# Access Compliance Report

## Public Rights-of-Way

Intersection ID: 50441	Main Street: ALICE_MCGINN_DR	Cross Street: COPPER_MOUNTAIN_BV	Location: SW
ADA ID: D3B1D714DF90	Ramp Type: PerpDiag	Initial Pass/Fail: Fail	Overall Compliance: No
		Severity Score: 25

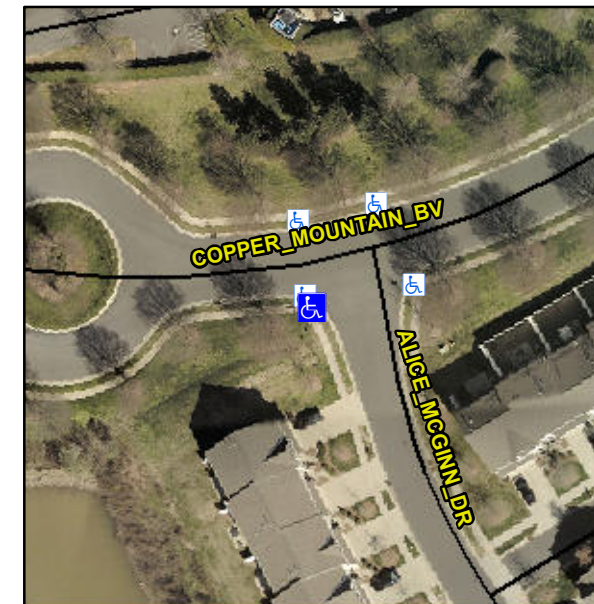
**Not Found, R304.5.3**

Compliance	Description	Data	Compliance	Description	Data
N/A	Ramp Length (in)	46.0	Yes	Ramp Slope (%)	5.5
Yes	Ramp Width (in)	48.0	No	Ramp XSlope (%)	8.8
N/A	Flare Type LT	N/A	N/A	Flare Type RT	N/A
N/A	Flare Slope LT (%)	N/A	N/A	Flare Slope RT (%)	N/A
N/A	Flare Traversable LT?	N/A	N/A	Flare Traversable RT?	N/A
N/A	Landing Length (in)	N/A	N/A	DWS Provided?	N/A
N/A	Landing Width (in)	N/A	N/A	DWS Contrast?	N/A
N/A	Landing Slope (%)	N/A	N/A	DWS Length (in)	N/A
N/A	Landing X Slope (%)	N/A	N/A	DWS Full Width?	N/A
N/A	Landing Curb? (Y/N)	N/A	N/A	DWS Offset (in)	N/A
N/A	Shared Landing?	N/A			
N/A	Gutter Ponding?	N/A	N/A	Gutter Slope (%)	N/A
N/A	Gutter Lip Ht (in)	N/A	N/A	Gutter X Slope (%)	N/A
N/A	Painted X Walk1?	No	N/A	Painted X Walk2?	No
	X Walk 1 Direction	To E		X Walk 2 Direction	To N
N/A	X Walk 1 Width (in)	N/A	N/A	X Walk 2 Width (in)	N/A
	X Walk 1 Slope (%)	0.8		X Walk 2 Slope (%)	4.8
	X Walk 1 X Slope (%)	0.7		X Walk 2 X Slope (%)	4.5

**Remove & Replace Curb Ramp With Two New Directional Ramps or Equivalent.**
